Subject: Issuance of Amendment No. 14 to Facility Operating License NPF-35 and Amendment No. 6 to Facility Operating License NPF-52 - Catawba Nuclear Station, Units 1 and 2

These amendments modify Technical Specifications related to application of a positive moderator temperature coefficient and to reflect the Cycle 2 refueling for Unit 1.

AMENDMENT NO. 14 TO FACILITY OPERATING LICENSE NPF-35 -
CATAWBA NUCLEAR POWER STATION, UNIT 1
AMENDMENT NO. 6 TO FACILITY OPERATING LICENSE NPF-52 -
CATAWBA NUCLEAR POWER STATION, UNIT 2

FIGURE 3.1-1a

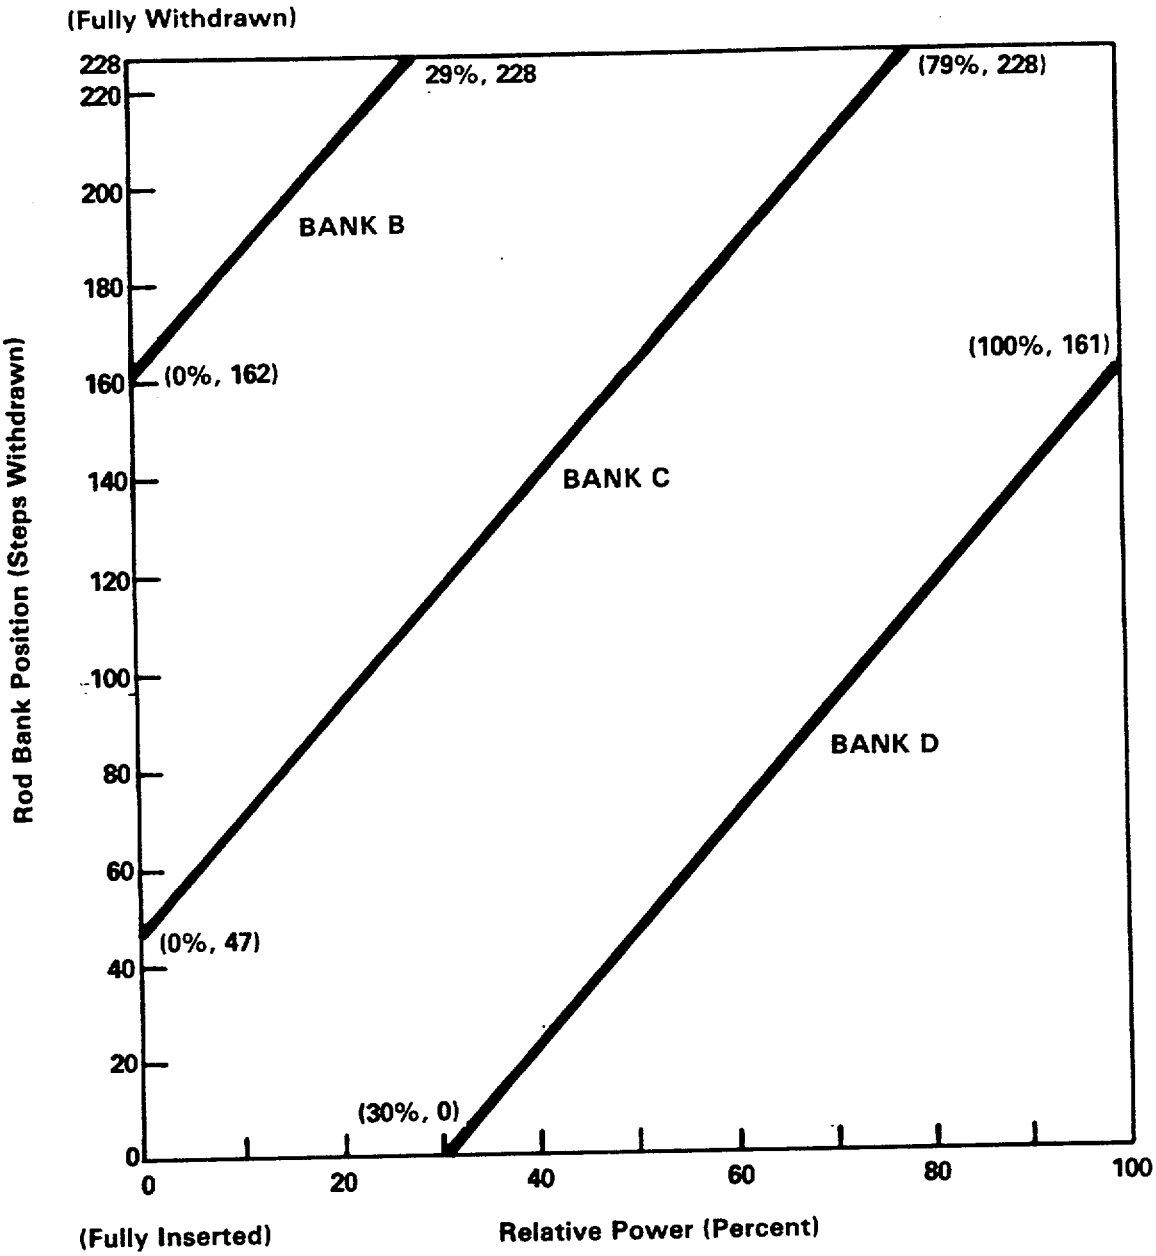
The RSE provides a table of Cycle 2 kinetics characteristics which are compared with the current limits based on previously approved accident analyses. The RSE also provides a table showing the results of the calculated Cycle 2 control rod worths and requirements at the most limiting condition during the cycle (end-of-life). These results include a standard 10% allowance for calculational uncertainty. From these results the staff concludes that sufficient control rod worth will be available to provide the required shutdown margin for Cycle 2 operation. Control rod insertion limits were increased for less than 100% power for Cycle 2. Since the required shutdown margin is maintained, the TS change proposed to reflect the increased insertion is acceptable.

FIGURE 3.1-0
MODERATOR TEMPERATURE COEFFICIENT VS. POWER LEVEL

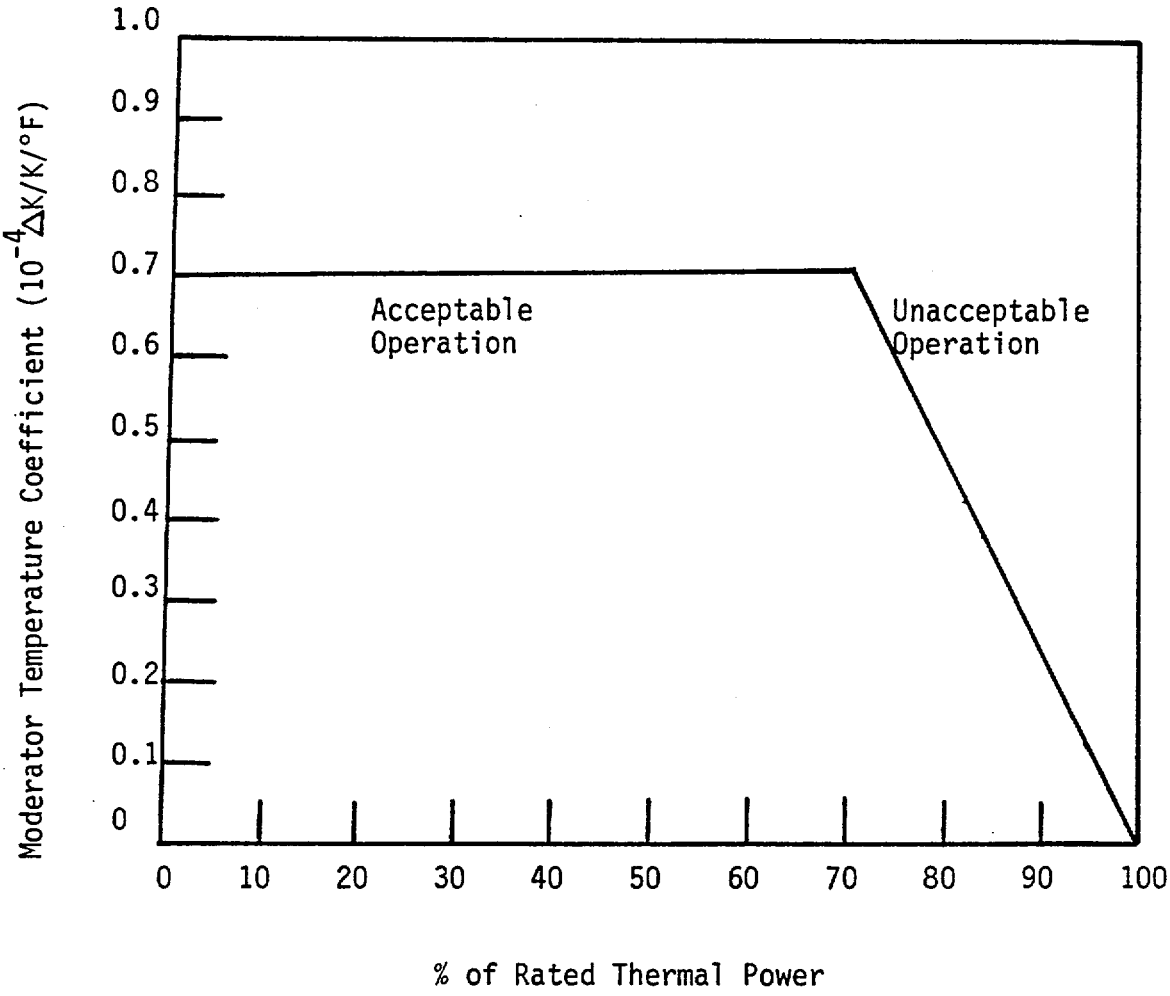
a. Less positive than the limits shown in Figure 3.1-0;

a. With the MTC more positive than the limits shown in Figure 3.1-0, operation in MODES 1 and 2 may proceed provided:

1. Control rod withdrawal limits are established and maintained sufficient to restore the MTC to less positive than the limits shown in Figure 3.1-0 within 24 hours or be in HOT STANDBY within the next 6 hours. These withdrawal limits shall be in addition to the insertion limits of Specification 3.1.3.6;

By letter dated July 15, 1986 (Ref. 1), Duke Power Company (the licensee) made an application to amend facility operating licenses NPF-35 and NPF-52 for Catawba Nuclear Station Units 1 and 2, respectively, to reflect the Cycle 2 refueling and related Technical Specification (TS) changes for Unit 1 and a TS change for both Units related to application of a positive Moderator Temperature Coefficient (MTC). A second letter (Ref. 2) provided some TS pages inadvertently omitted from Reference 1. The proposed TS change applicable to both Units consists of increasing the allowable positive MTC and most negative EOL MTC. The previous TS allowed a +5 pcm/°F MTC at power levels up to 70% power, and 0 at power levels about 70%. The proposed revision would allow an MTC of +7 pcm/°F up to 70%, decreasing linearly above 70% power to 0 pcm/°F at 100% power.

FIGURE 3.2-1a
AXIAL FLUX DIFFERENCE LIMITS AS A FUNCTION OF RATED THERMAL POWER (UNIT 1)

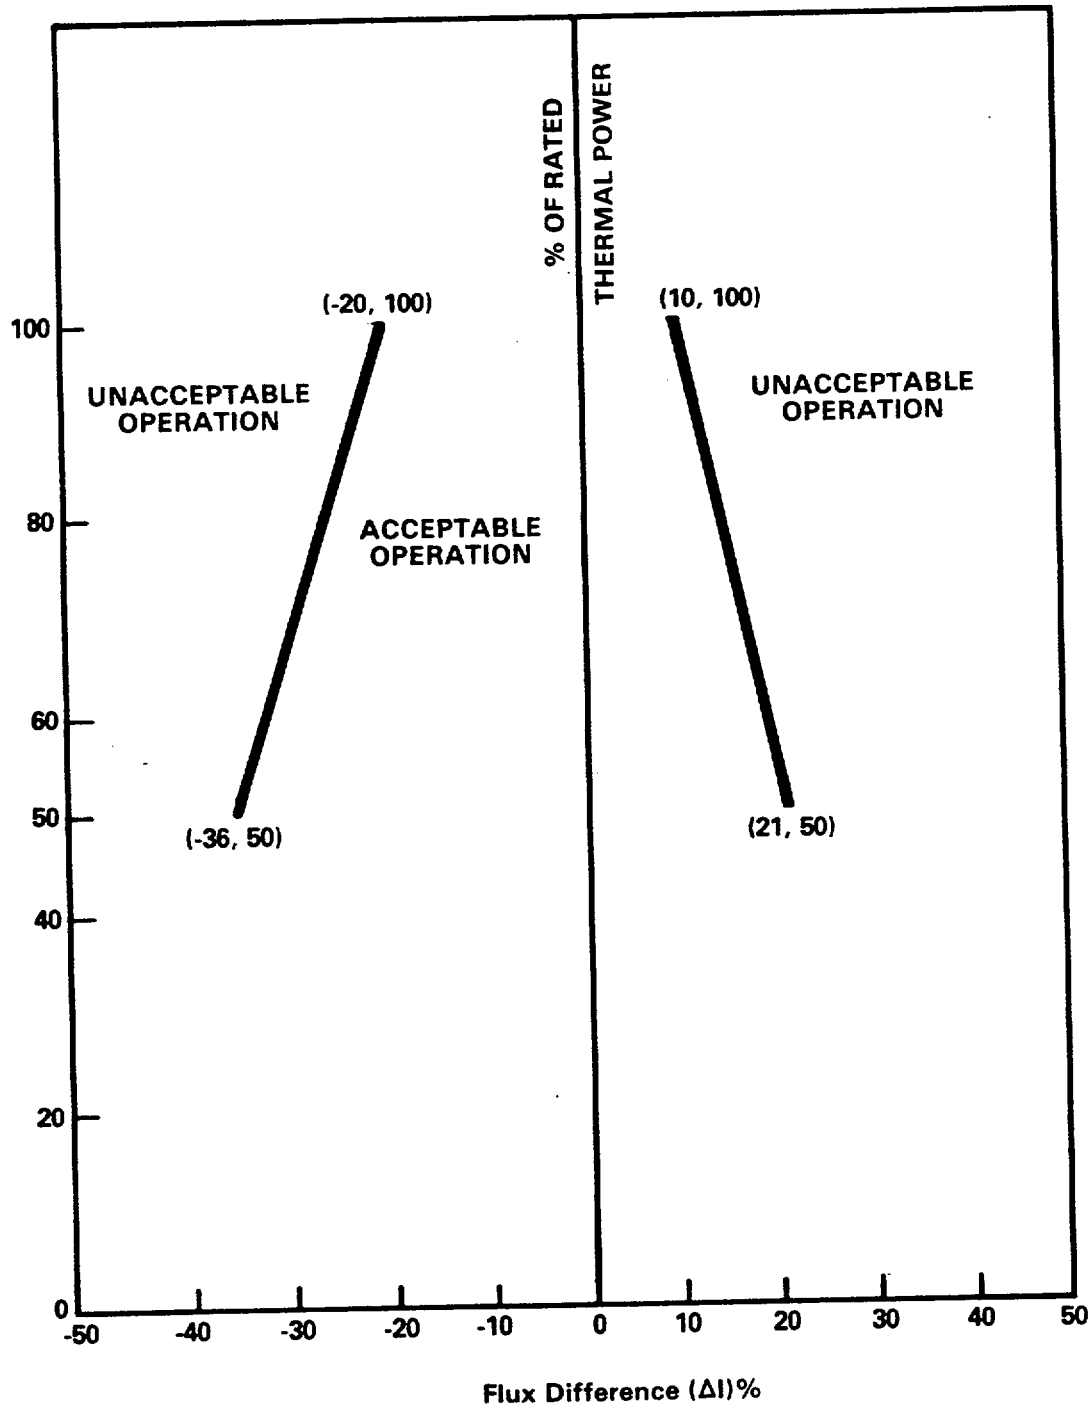
The power distributions produced by the cycle-specific RAOC analysis were analyzed for normal operation and Condition II events. Limits on the allowable operating flux difference as a function of power level from these considerations were found to be less restrictive than those resulting from LOCA F_Q considerations. The Condition II analyses generate DNB core limits and resultant Over-Temperature Delta-T setpoints. These generated a change to the $F(\Delta I)$ function in the TS. The change is acceptable because it results from cycle-specific calculations using approved methods (Refs. 6 and 7). Therefore, the staff concludes that the Cycle 2 thermal-hydraulic analysis is acceptable.
